Access Compliance Report

Public Rights-of-Way

Intersection ID: 10021330	Main Street: BLAKENEY_HEATH_RD	Cross Street: N/A	Location: NW
ADA ID: 33F278AB4296	Ramp Type: Perp	Initial Pass/Fail: Fail	Overall Compliance: No
Severity Score: 1.25			
Codes/Mitigation Info/Possible Solution		Field Measurements/Component Compliance

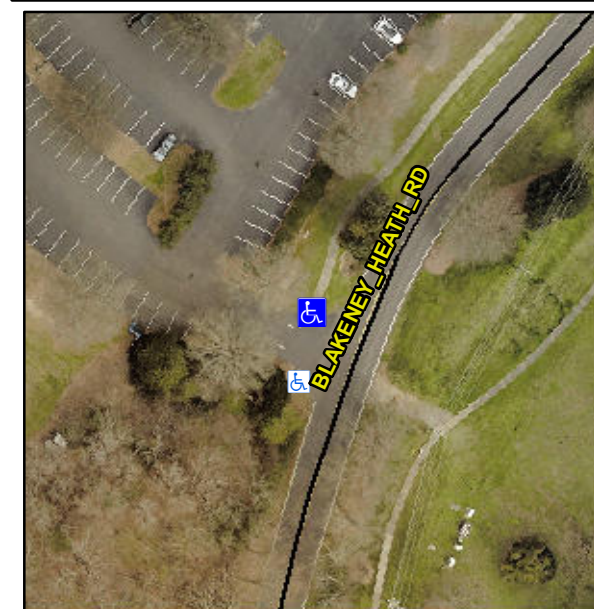
Not Found, R304.5.3

Compliance	Description	Data	Compliance	Description	Data
N/A	Ramp Length (in)	84.0	Yes	Ramp Slope (%)	5.9
Yes	Ramp Width (in)	48.0	No	Ramp XSlope (%)	2.2
N/A	Flare Type LT	N/A	N/A	Flare Type RT	N/A
N/A	Flare Slope LT (%)	N/A	N/A	Flare Slope RT (%)	N/A
N/A	Flare Traversable LT?	N/A	N/A	Flare Traversable RT?	N/A
N/A	Landing Length (in)	N/A	N/A	DWS Provided?	N/A
N/A	Landing Width (in)	N/A	N/A	DWS Contrast?	N/A
N/A	Landing Slope (%)	N/A	N/A	DWS Length (in)	N/A
N/A	Landing X Slope (%)	N/A	N/A	DWS Full Width?	N/A
N/A	Landing Curb? (Y/N)	N/A	N/A	DWS Offset (in)	N/A
N/A	Shared Landing?	N/A			
N/A	Gutter Ponding?	N/A	N/A	Gutter Slope (%)	N/A
N/A	Gutter Lip Ht (in)	N/A	N/A	Gutter X Slope (%)	N/A
N/A	Painted X Walk1?	No	N/A	Painted X Walk2?	N/A
	X Walk 1 Direction	To SE		X Walk 2 Direction	N/A
N/A	X Walk 1 Width (in)	N/A	N/A	X Walk 2 Width (in)	N/A
	X Walk 1 Slope (%)	2.7		X Walk 2 Slope (%)	N/A
	X Walk 1 X Slope (%)	0.0		X Walk 2 X Slope (%)	N/A

Remove & Replace Entire Ramp.
